10/695,360

Anthony J. Bonfardecì

Office Action Summary

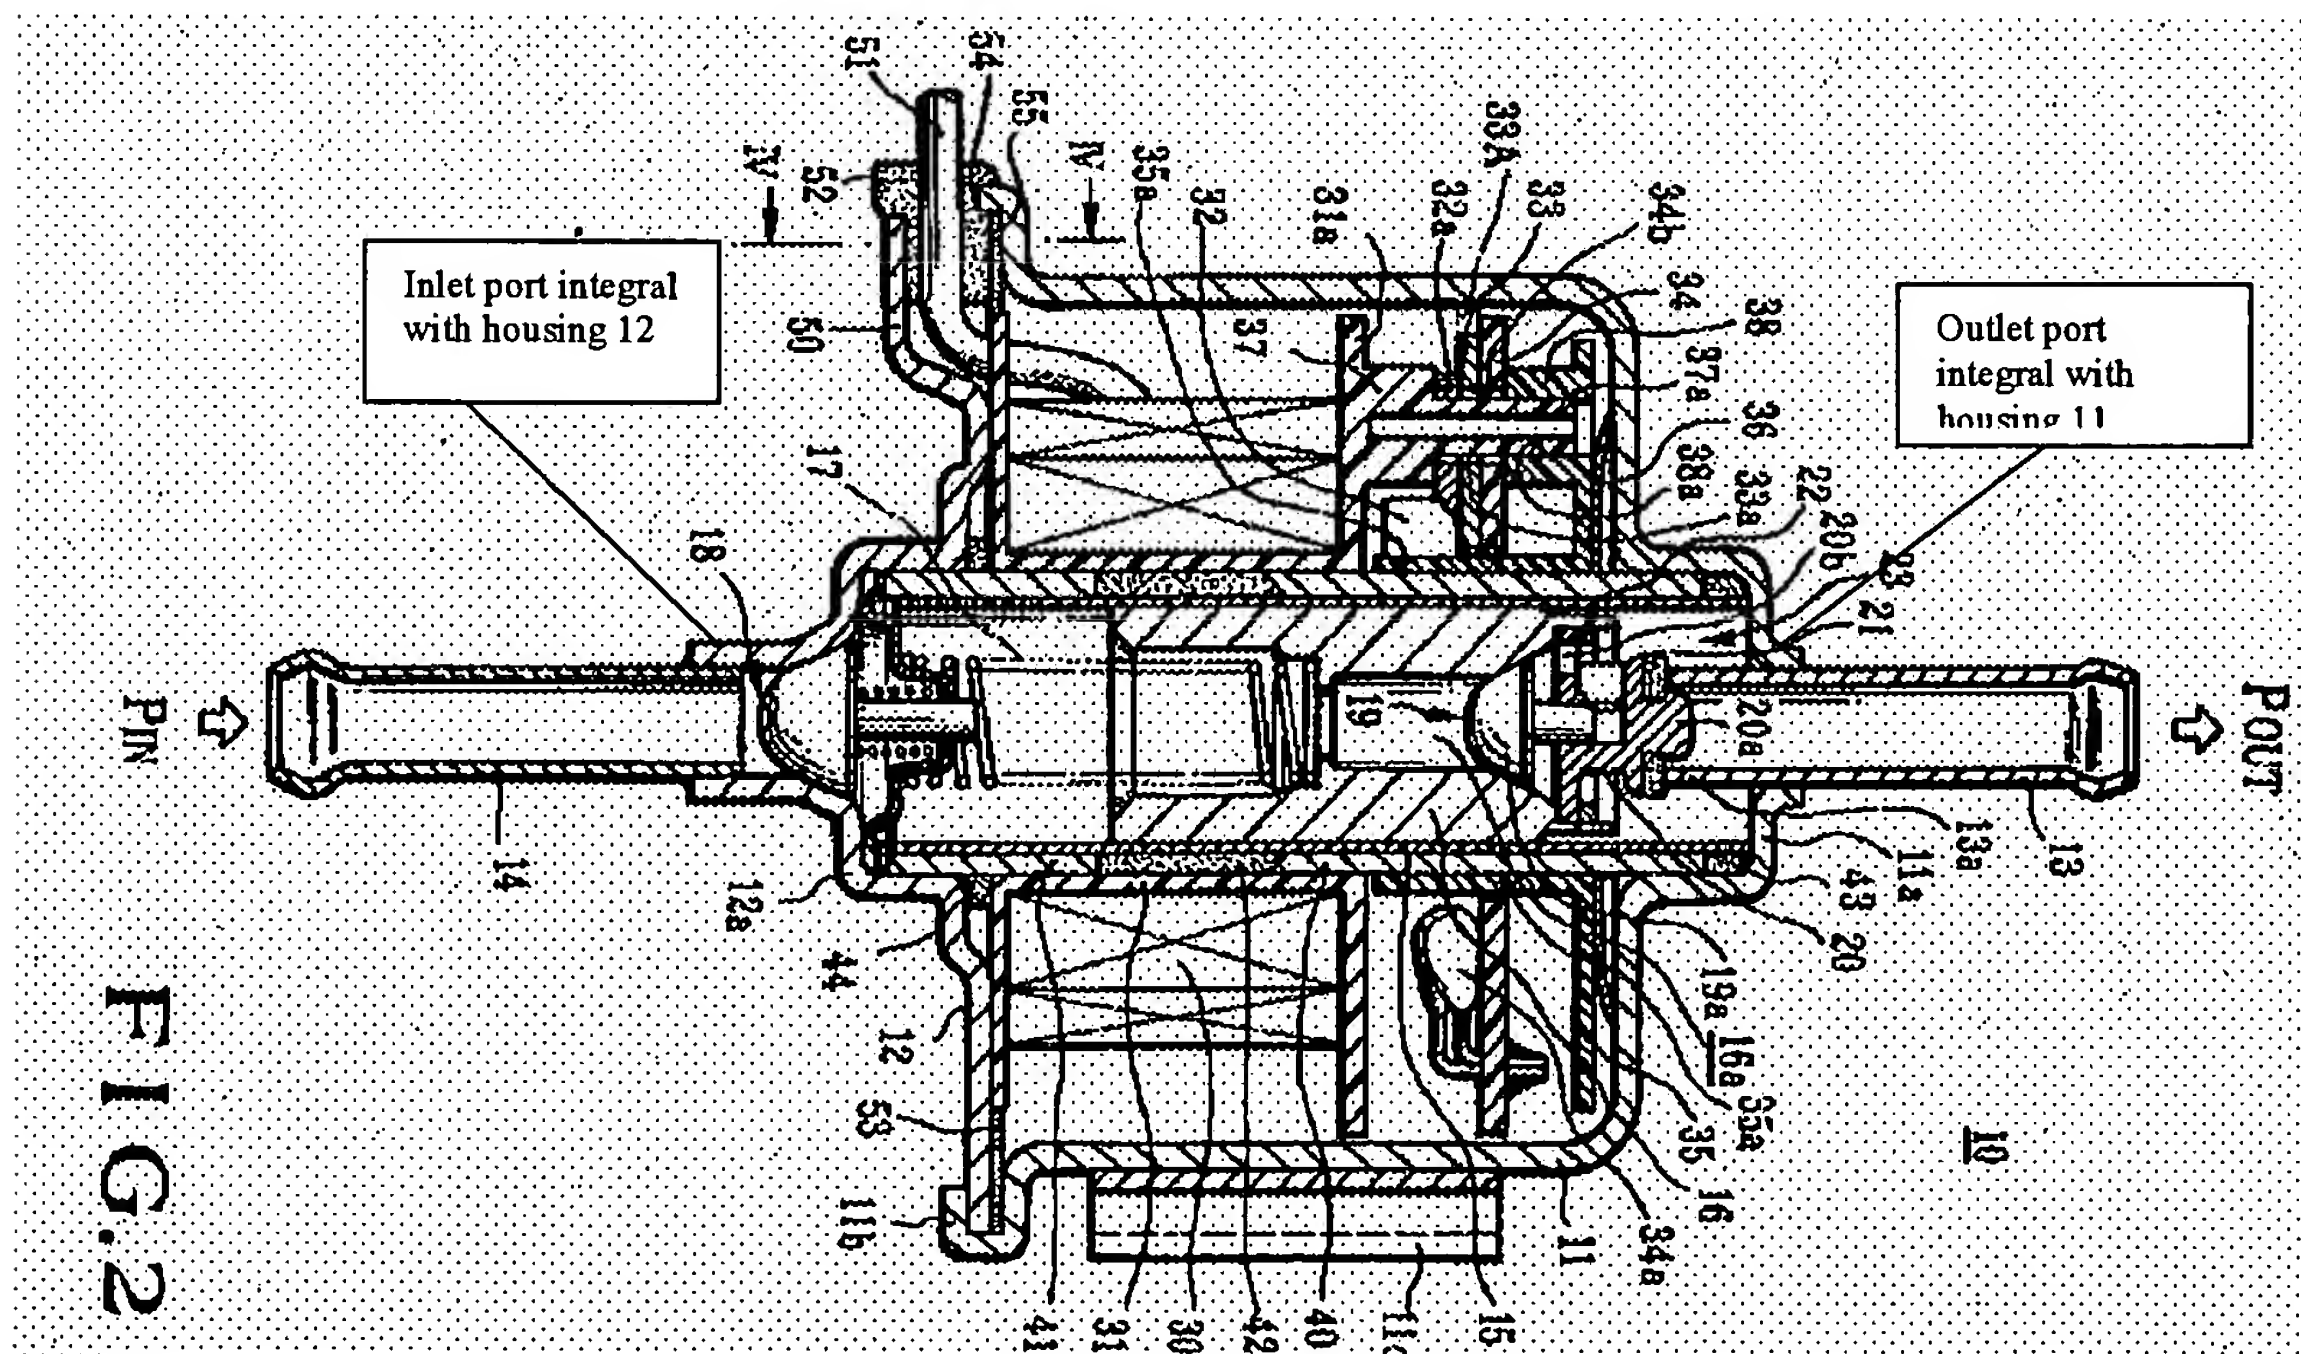
With respect to claim 1, **Masaka** teaches an electromagnetic fuel pump, comprising: a pump; electronic switching circuitry (column 6 lines 51-57) for controlling an electromagnetic coil 30 operatively arranged operate said pump; and, a housing (11, 12) arranged to house said pump and said coil, said housing comprising an integral (see column 3 lines 29-33) inlet port and outlet port. See particularly **Figure 2** above.

With respect to claim 8, **Masaka** teaches that the inlet port further comprises a bore; wherein said bore is operatively arranged for adhesion to an inlet fuel hose coupling nipple 14. See particularly **Figure 2** above.

With respect to claim 11, **Masaka** teaches that the outlet port further comprises a bore; wherein said bore is operatively arranged for adhesion to an outlet fuel hose coupling nipple 13. See particularly **Figure 2** above.

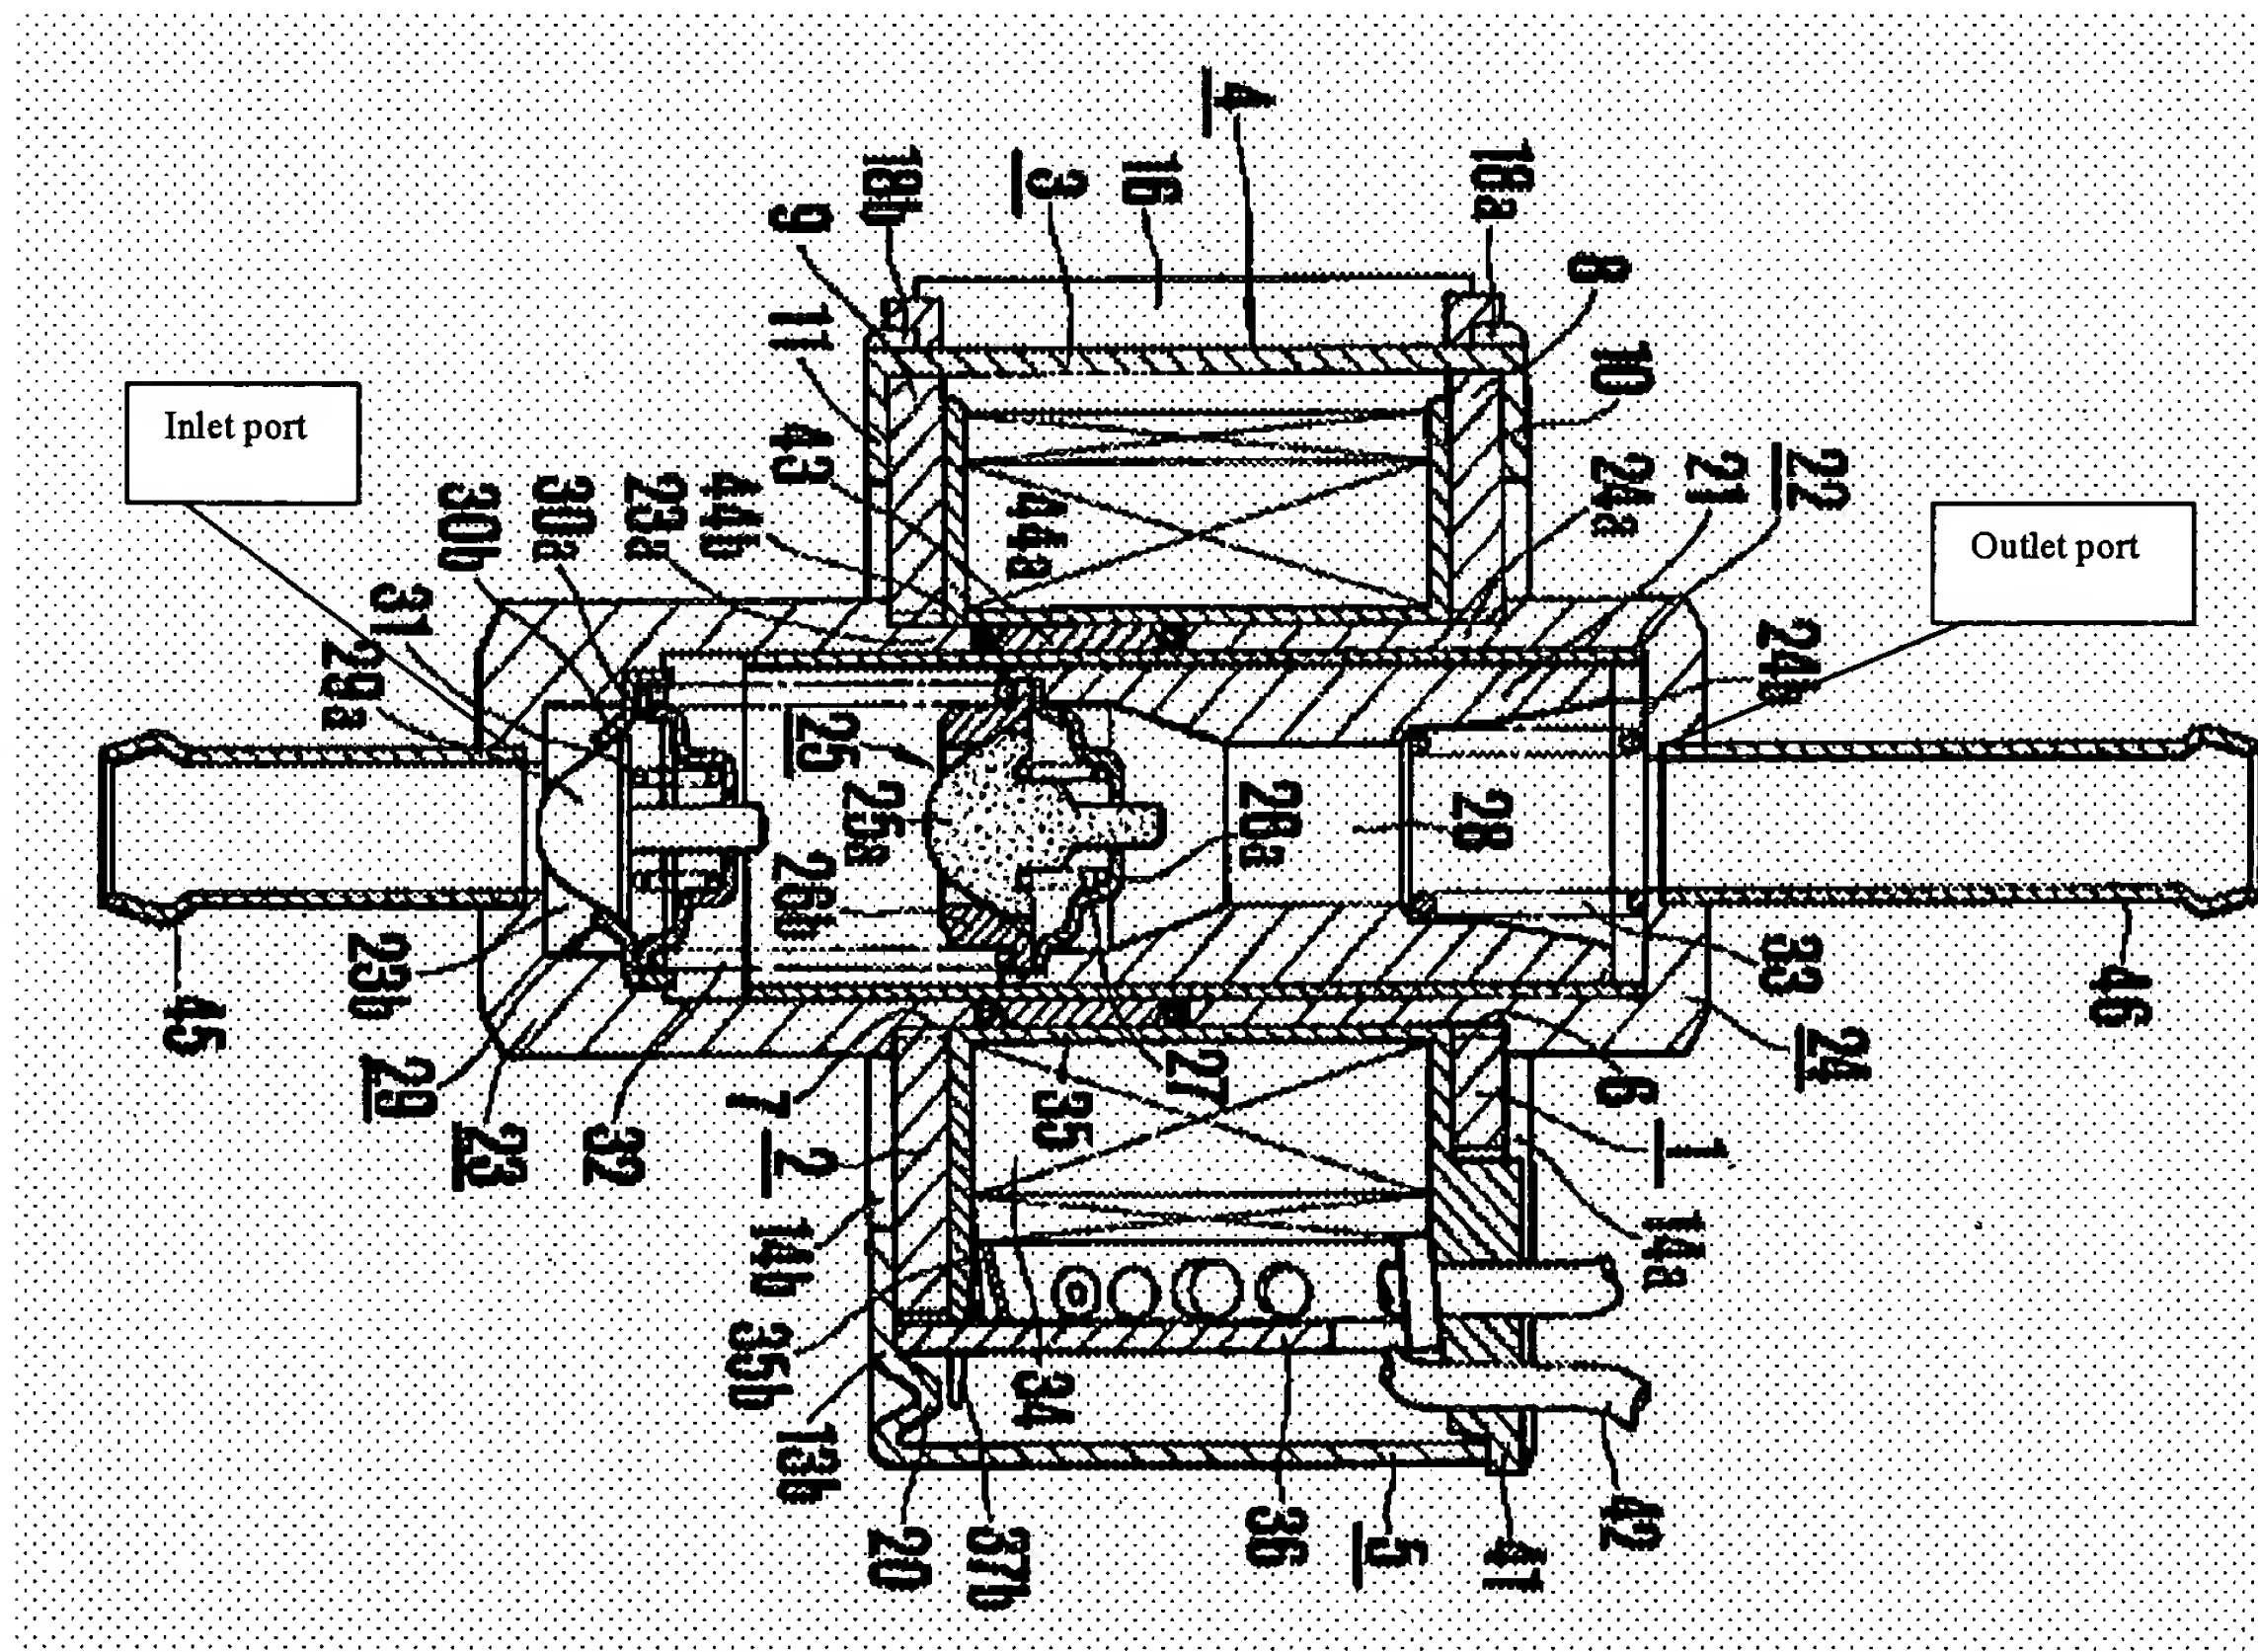
been obvious to one of ordinary skill in the art at the time the invention was made to have replaced **Masaka's 653** inserts by **Masaka's 842** inserts in order to easily remove/replace said inserts in case of failure or maintenance. See particularly Figure 2 of Maska'842.

With respect to claim 2, **Masaka** teaches that the electromagnetic fuel pump further comprising a drive circuit 36 housed within said housing, said drive circuit operatively arranged to drive said coil. See particularly **Figure 2**.

With respect to claim 7, **Masaka** teaches that the inlet port 7 comprises a threaded insert 23. See particularly Figure 2 and column 3 lines 49-52.

With respect to claim 10, **Masaka** teaches that the outlet port 6 comprises a threaded insert 24. See particularly Figure 2 and column 3 lines 49-52.
